K2 OWNER'S MANUAL ERRATA

Rev. G-6, August 30, 2008

Figure 5-9

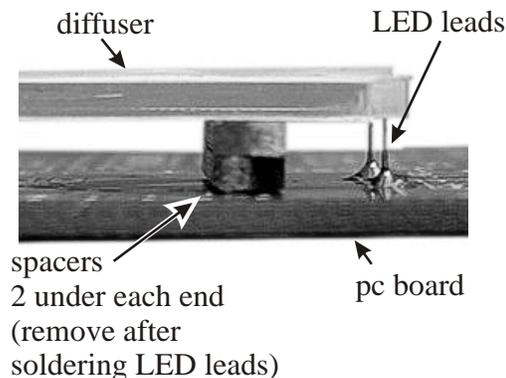
2. Page 27, right column: Delete the two existing steps and figures and replace them with the following:

Position the backlight assembly between the mounting holes labeled D2 and D3 as shown in Figures 5-9 and 5-10 with two 3/4" (19 mm) long spacers under each end. *The diffuser must be parallel to and 1/8" (3 mm) above the PC board.* Use a rubber band to hold the backlight assembly and spacers in place
